Re: Indian Point Unit No. 2  
Docket No. 50-247

Subject: Response to NRC Questions on the AMSAC and SAS/SPDS Submittals

Response to NRC's Questions on AMSAC

FIGURE 1-2.1

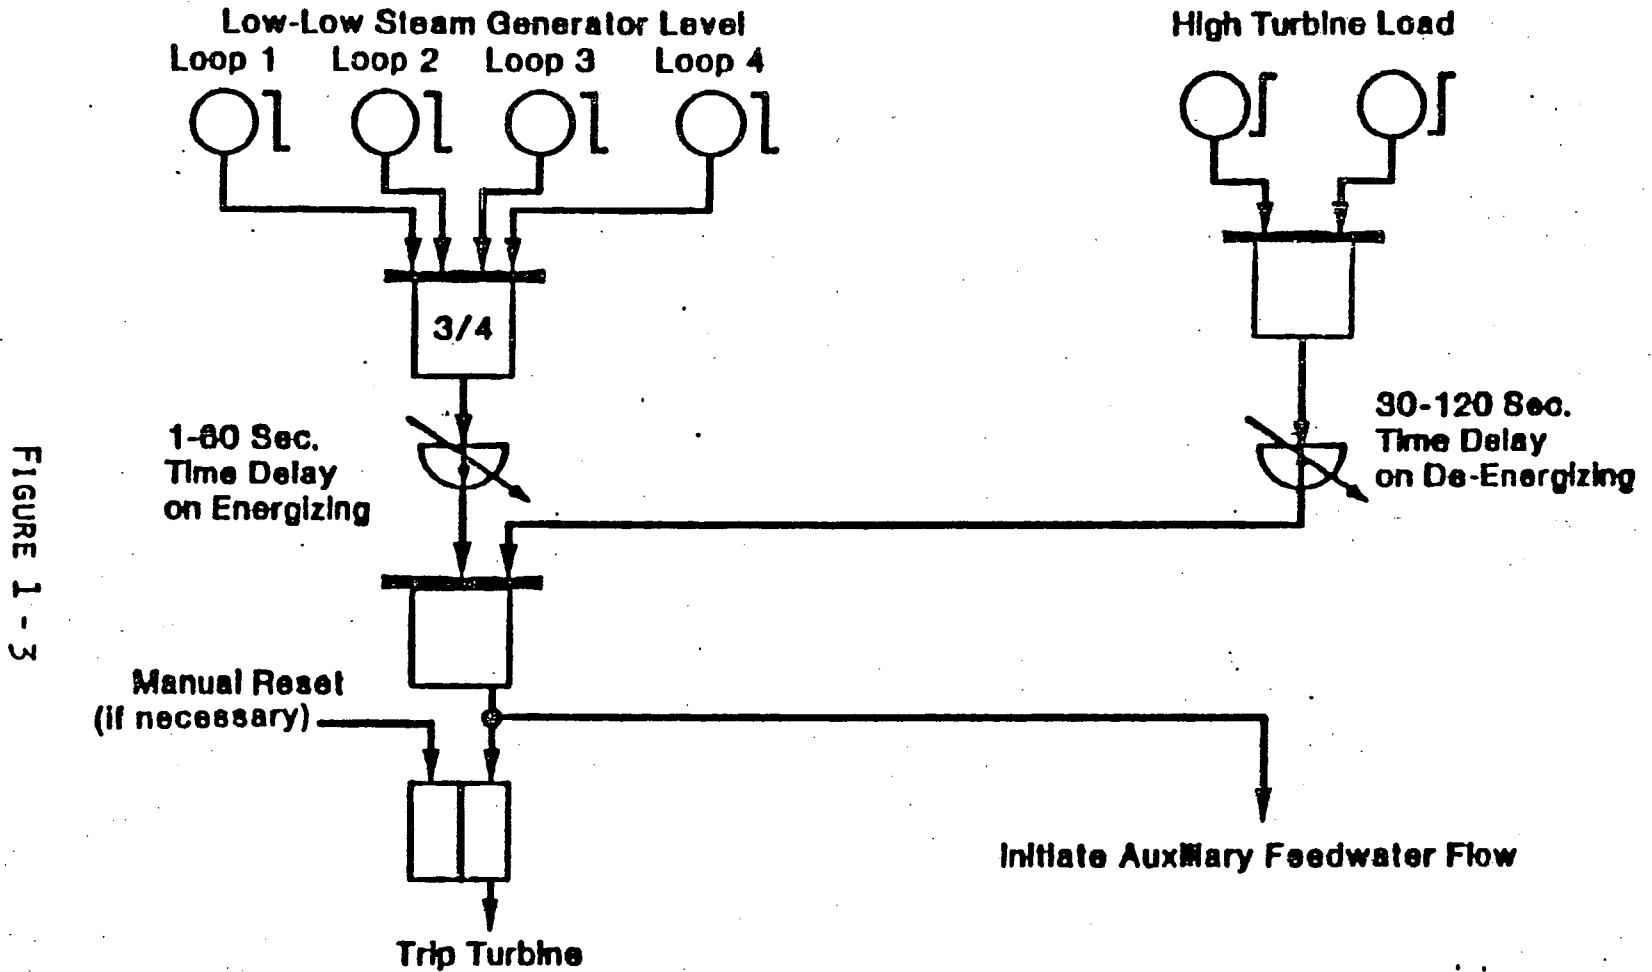
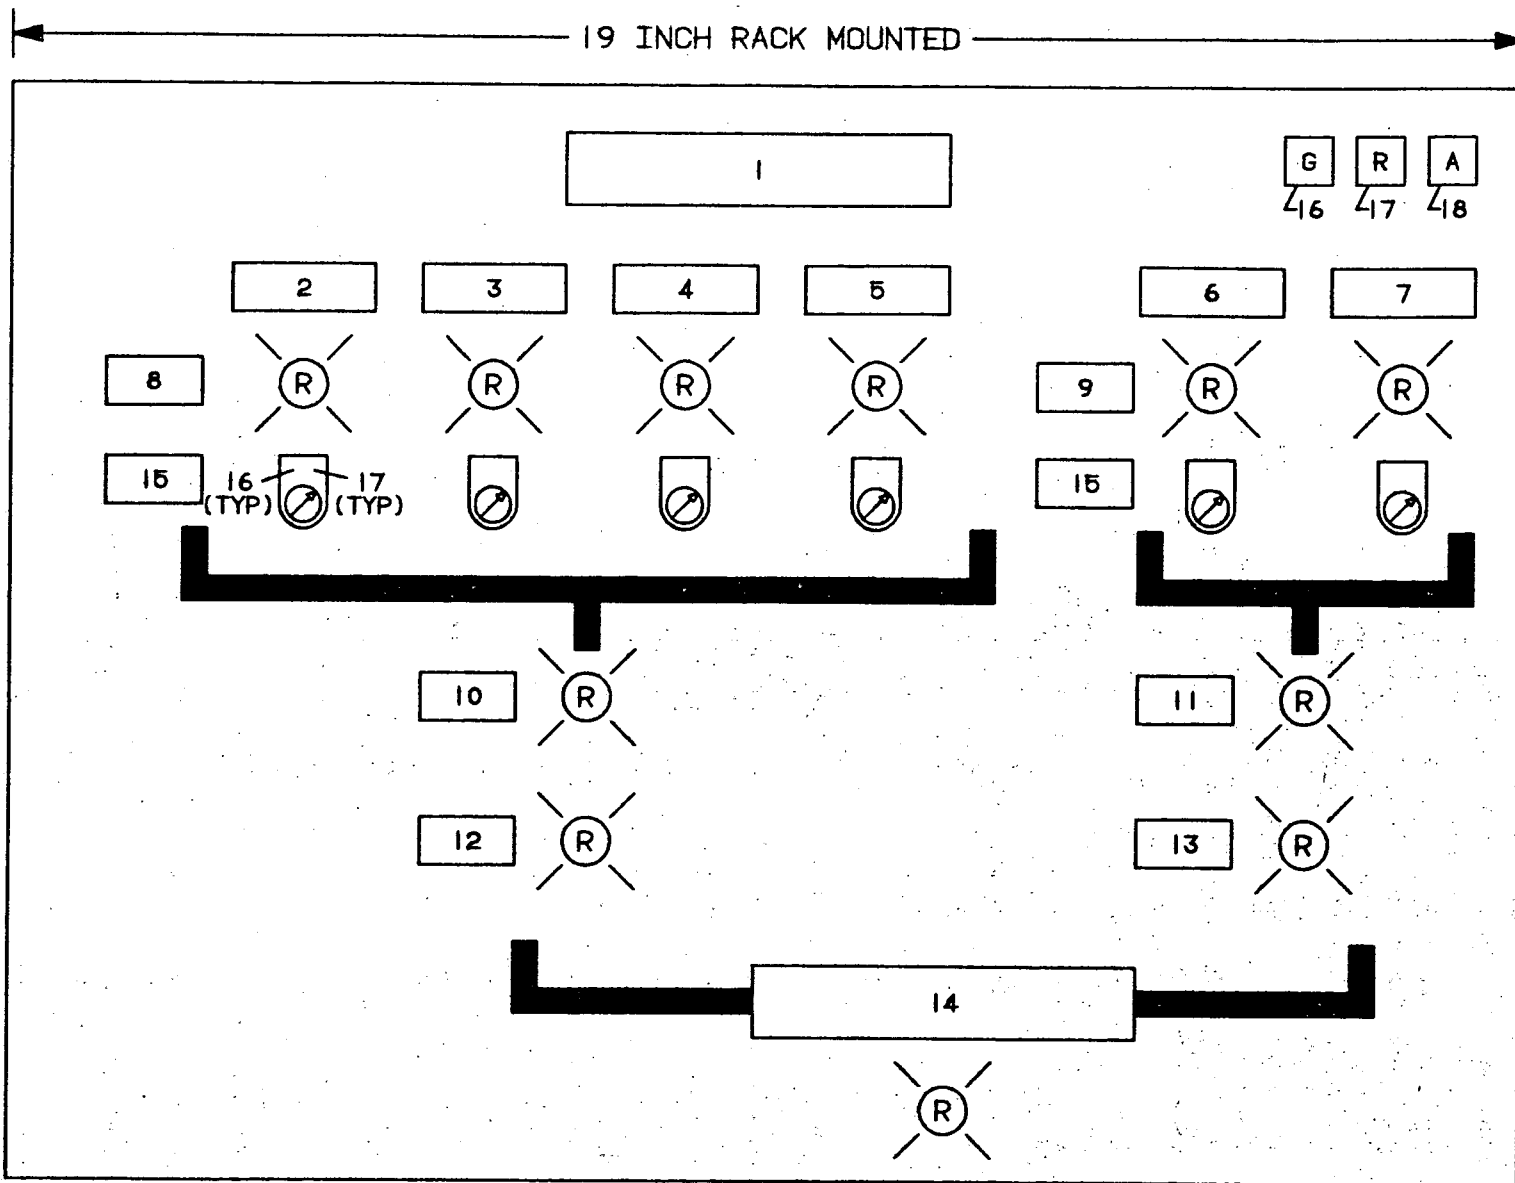
2. Supply a logic diagram of AMSAC. In particular, take the generic Westinghouse diagram from the WCAP and:
  - a) Show the plant specific interfaces.
  - b) Show specific instrument and control logic flows.

In addition, identify which diagram is used from the WCAP.

The plant specific AMSAC design for the Indian Point Unit No. 2 (IP-2) AMSAC is based on the generic logic 1 option (Steam Generator Low Level Actuation) described in Westinghouse WCAP-10858P-A Figure 1-3, which is attached (Figure I-2.1).

FIGURE II-2.1

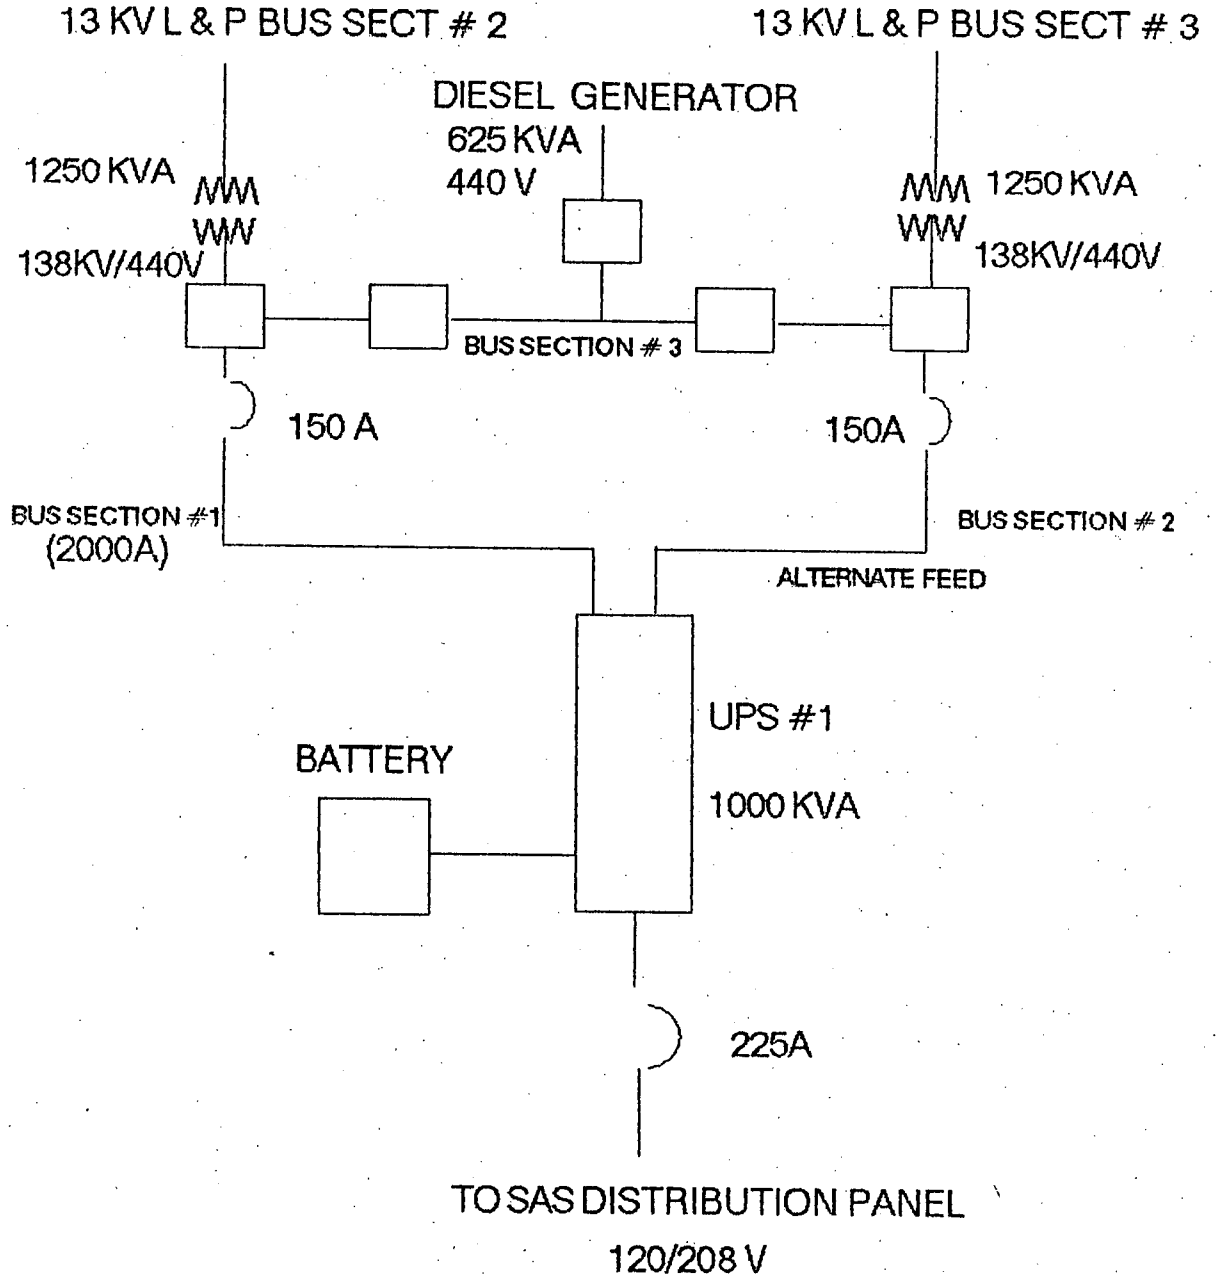
2. Supply a block diagram showing SAS/SPDS input/output signals and isolators. The block diagram should:
  - a) Show Class 1E signals coming in, show the isolation, show the signal going out to SAS/SPDS and the SAS/SPDS display.
  - b) Show the power supply going into the SAS/SPDS.
  - c) Show the non-1E signal going into and out of the SAS/SPDS.

Figure II-2.1, attached, shows the power supply going into the SAS/SPDS in response to item b.
